Technical Information

Subject: Air-to-Water Mono-bloc H20 (pump abnormality) Error

Figure 3

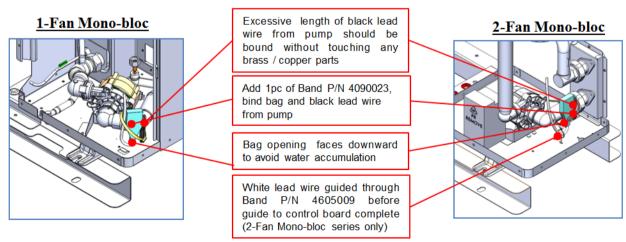
Starting from production in July 2017, the following changes will be implemented to prevent the condition from happening (refer Figure 3 for illustration):

- 1. Pump connector wire guiding direction is changed from horizontal to vertical with the opening of the plastic bag facing down towards the chassis to prevent water accumulation inside the bag.
- 2. Excess length of the pump lead wire and the plastic bag are bound with a band (part number 4090023) without touching any brass or metal parts.
- 3. For 2-Fan mono-bloc models, the white lead wire is guided through the band (part number 4605009) to the control board.
